## Technical change to DRI...LT

• PCN-number	20210401 Product change Notification D-SERIES DRI relays - status indicator
• date of publishing	1 <sup>st</sup> of April 2021

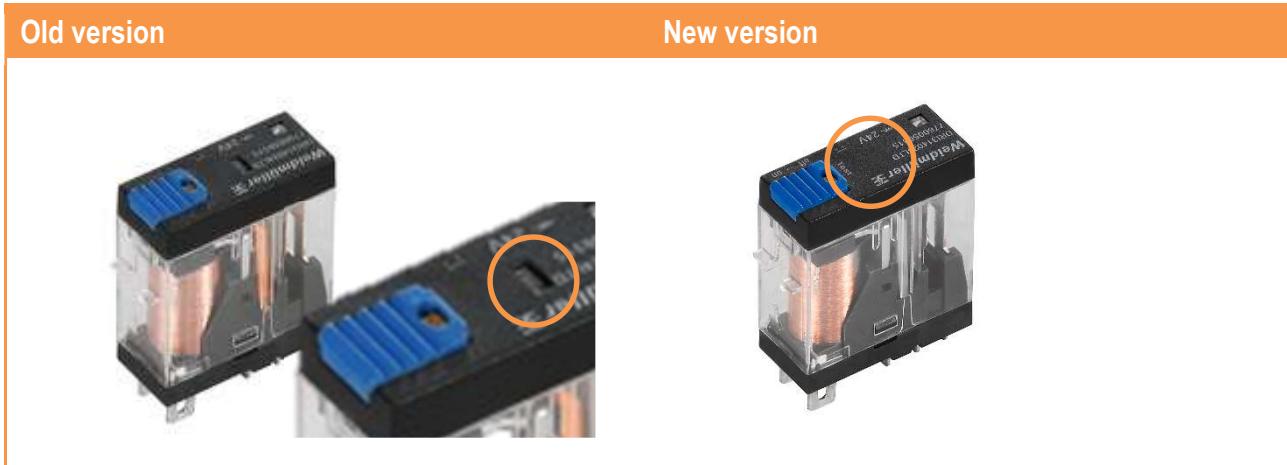
Additional to the integrated status indication LED, the product offers a mechanical switch-position indicator.

Mechanical switch-position indicator will be substituted by the status indication LED

Status indication via LED is most used in the market.
